MODIFICATION BULLETIN NO. 1 PAGE 1 OF 4

Model	DF 43	Volt/Hz	Date of Modification	Serial Number
Modified Article		No se	rial numbrt cut in i	nfotion
Reason for Modification	Parts catalog correction

Modification Bulletin

Model: DF43 Dat			eb-97	No: 002	1/1
Modified Article: Tapping Screw			Prepare	d by: K. Ugaeri	
From: QAC 2nd Fiel	ld Information Dept.		Checke	d by: S. Fujii	
Reason for Modification:	☐ Parts catalog correction☐ To facilitate assembly☑ Other	☐ Vendor ch	•	☐ To meet standards ()	3

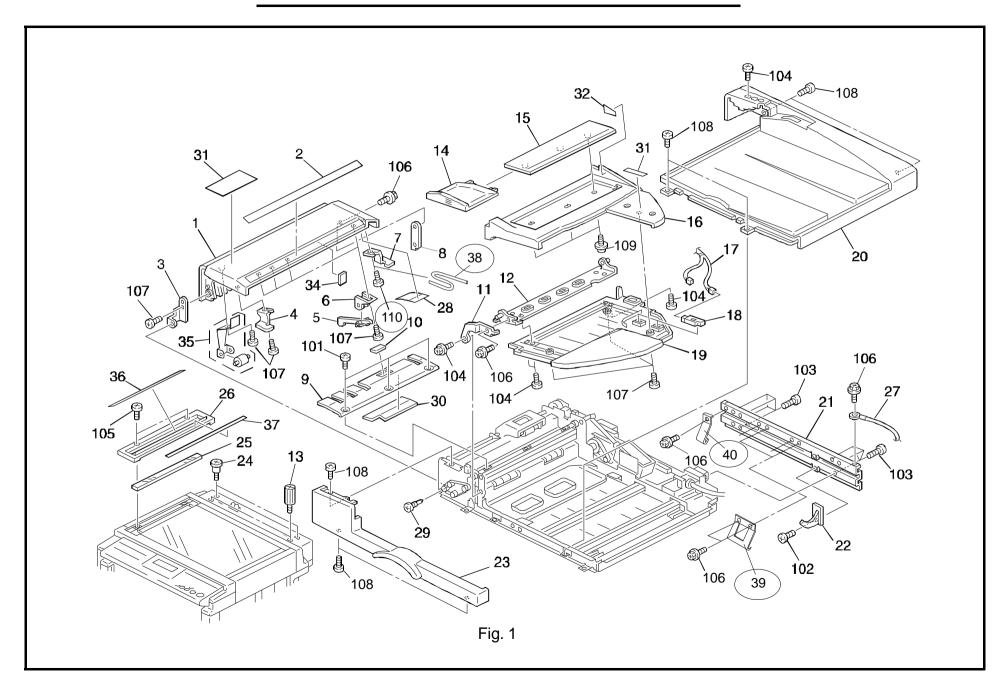
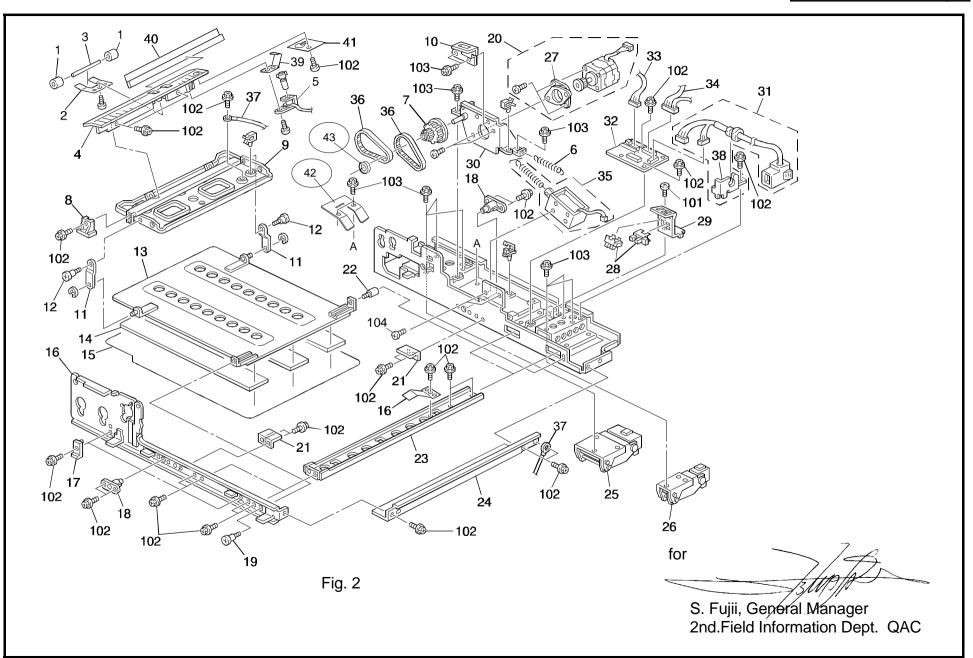
The following should be corrected. Please correct your part catalog.

1. The following parts have been modified.

Old Part Number	New Part Number	Description	Q'ty	Index No.	Page
A6281236	A6281261	Original Entrance Guide	1	9	3
A6282167	A6281262	Pad - Original Entrance Guide	1	10	3
A6281217	A6281257	Original Feed Belt	1	18	5
AA063144	A6281596	Left Transport Roller Spring	4	38	5
A6281582		Rear Spring - Exit Roller	2 → 0	23	7
	→ G0101106	Spring - Interlock	2 → 4	40	7
A6281511	A6281512	Separation Roller	1	5	7
A6281572	A6281566	Rear Bushing - Exit Roller	2	22	7
A6281581	A6281585	Lower Exit Roller	2	24	7
A6281571	A6281565	Front Bushing - Exit Roller	2	25	7

2. The following parts have been added.

New Part Number	Description	Q'ty	Index No.	Page	Fig. no.
A6282170	Lock Lever - Left Cover	1	38	3	1
A6281174	Right Grounding Plate - Hinge Bracket	2	39	3	1
A6281177	Left Grounding Plate - Hinge Bracket	1	40	3	1
04504010B	Tapping Screw - MX10		101	3	1
A6281176	Grounding Plate - Base	1	42	9	2
A6281829	Collar - 9X15X3	1	43	9	2

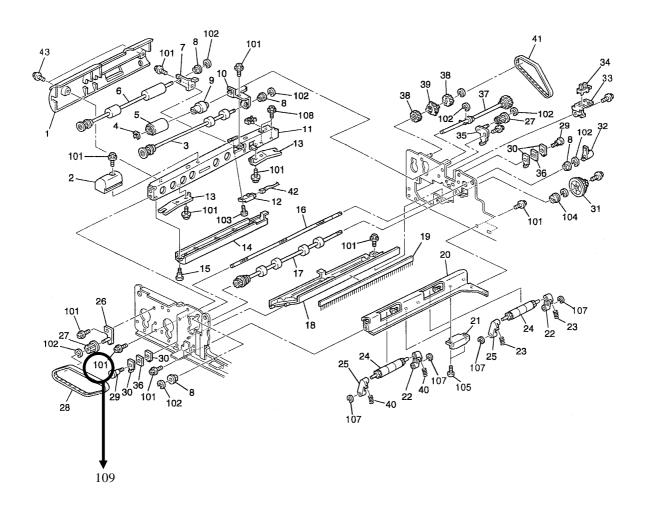
The Pull Out Guide (index 1 - A628 1541) may be bent by coming in contact with the screws. The length of the screws has been changed from 6 mm to 5 mm

Old part number	New part number	Description	Qty	Int	Page	Index	Note
04513006B		Tapping Screw - M3 x 6	4 - 0		6	101	
	04513005B	Tapping Screw - M3 x 5	0 - 4		6	109

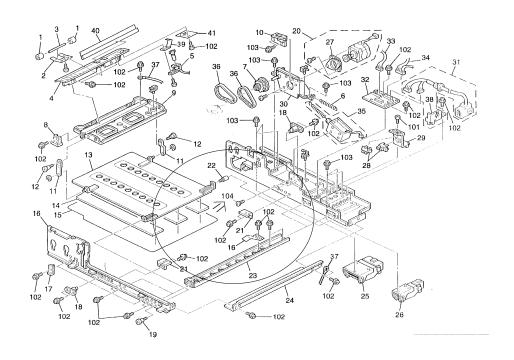
Old part	New part	Description	Qty	Int	Page	Index	Note
number	number						
03130040	A5902214	Philips Pan Head Screw - M3x4	2-2		9	104
